Comment #29 SIGNAL.indication

Pete Anslow, Ciena

IEEE P802.3bs Task Force, San Antonio, November 2016

SIGNAL.indication in stack without extender

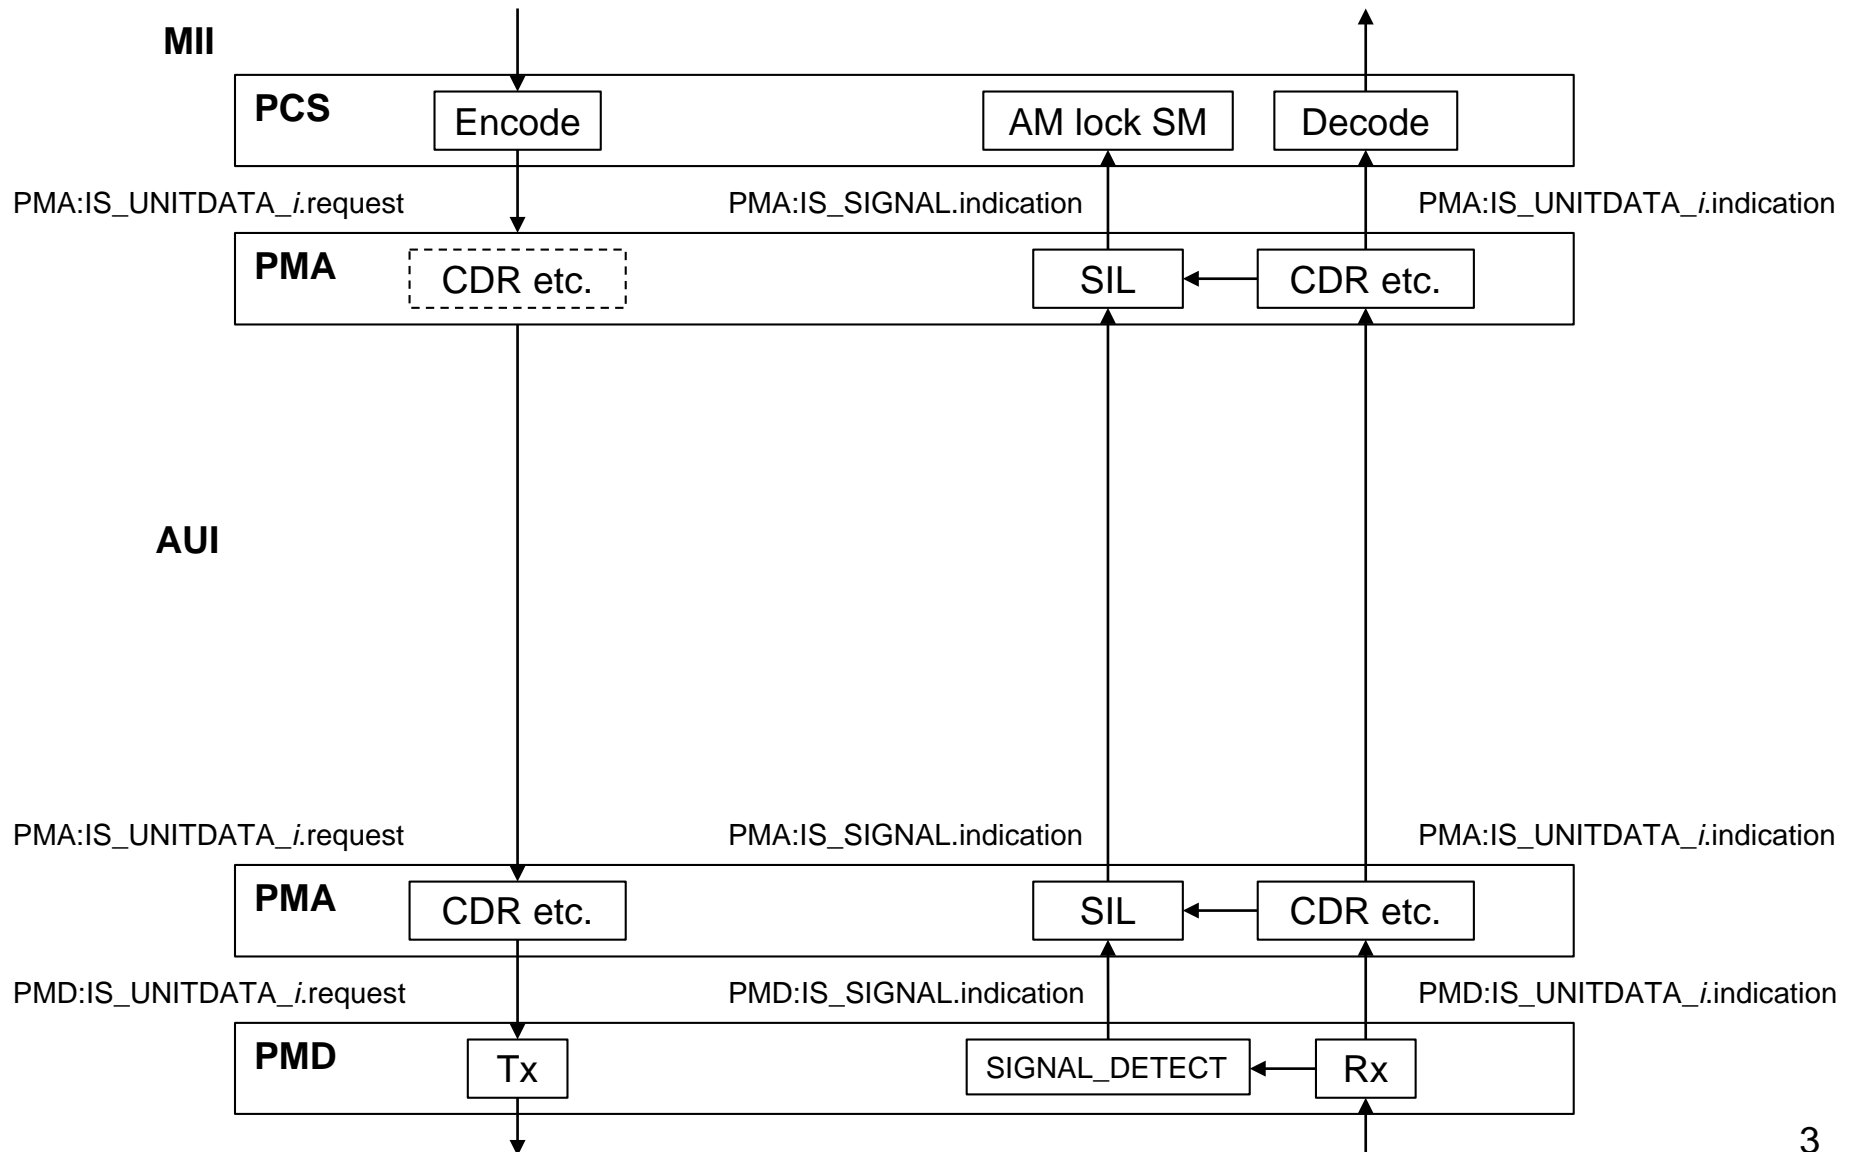
Comparing the signals to and from the PCS on slide 3 with those to and from the PHY XS on slide 4, they are the same except that the PHY XS is an “upside down” version of the PCS.

SIGNAL.indication in stack with extender

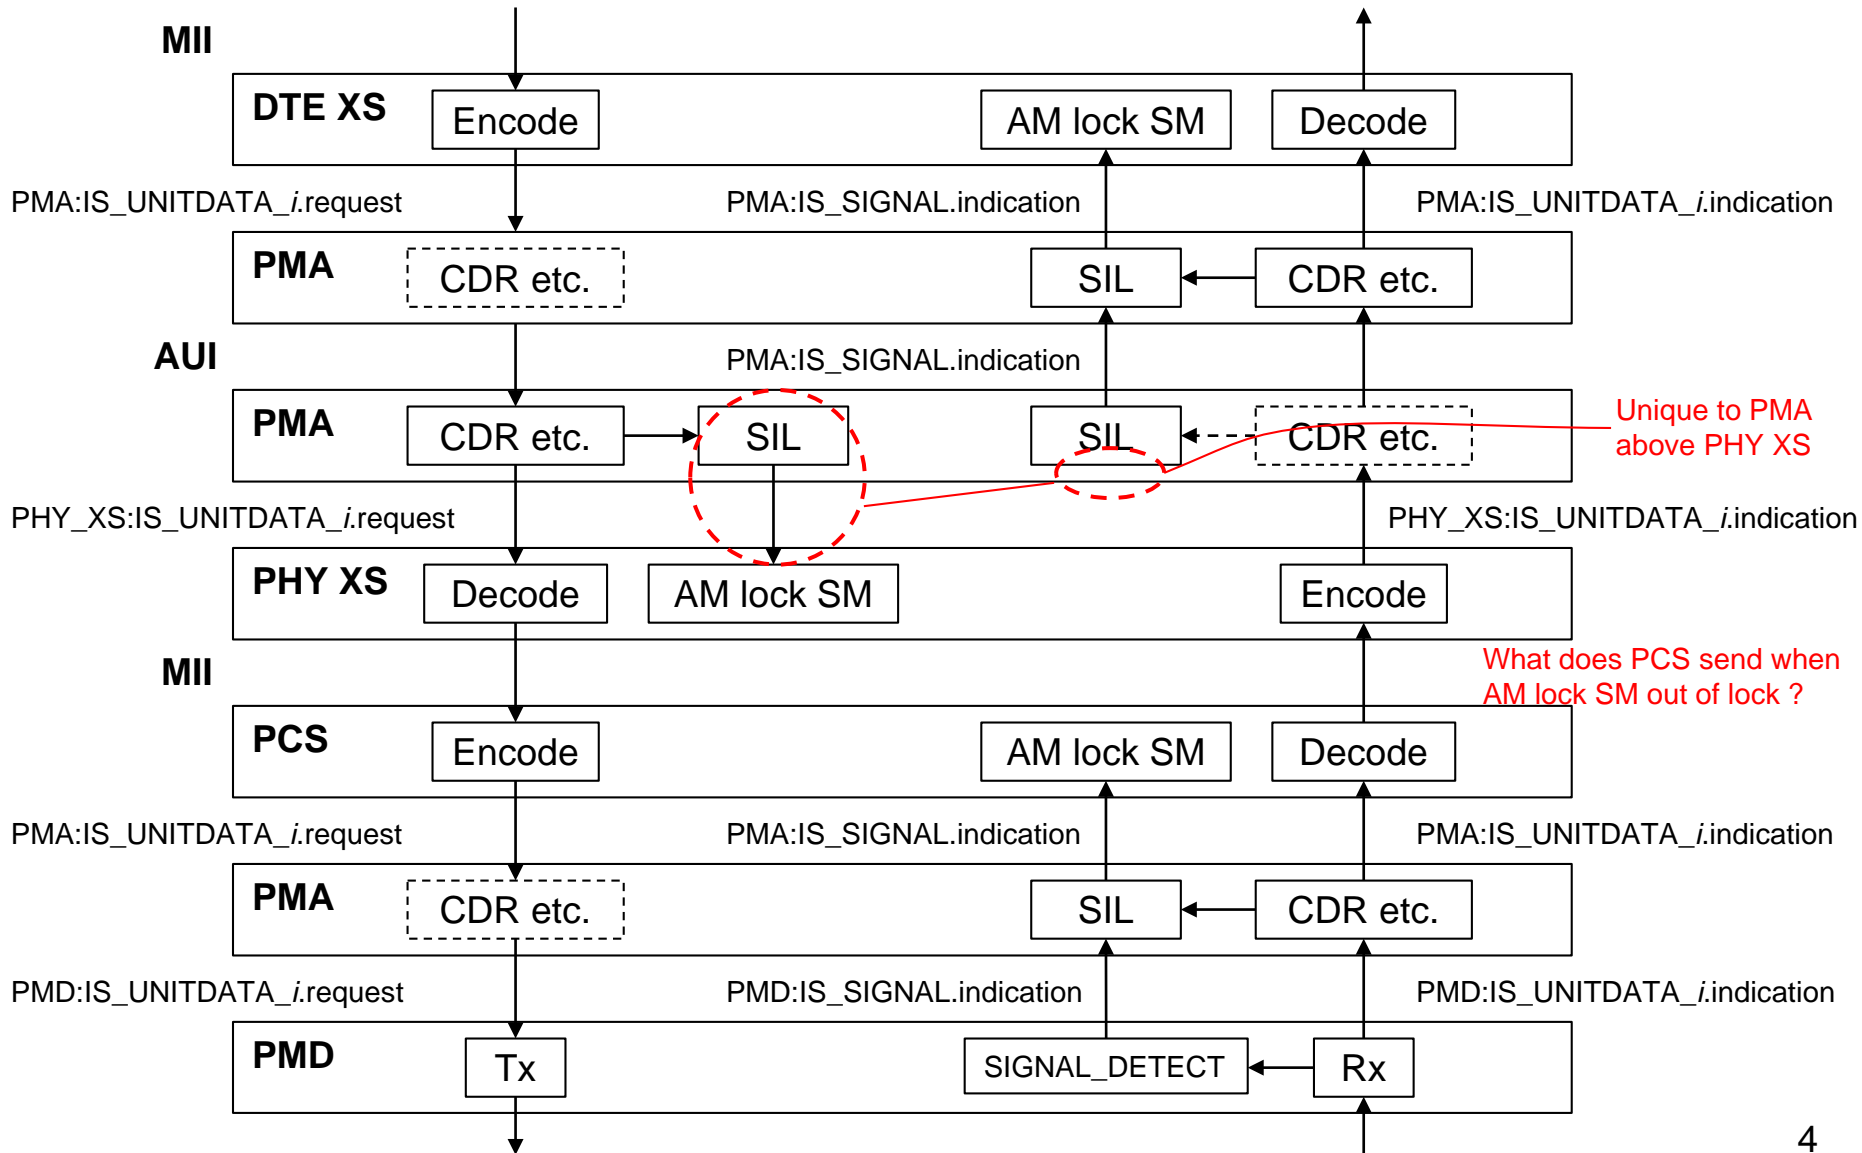
However, comparing the signals to and from the PMA sublayer above the PHY XS, these are different to a normal PMA in that it does not receive an `IS_SIGNAL.indication` from the layer below but it should provide an `IS_SIGNAL.request` to the layer below.
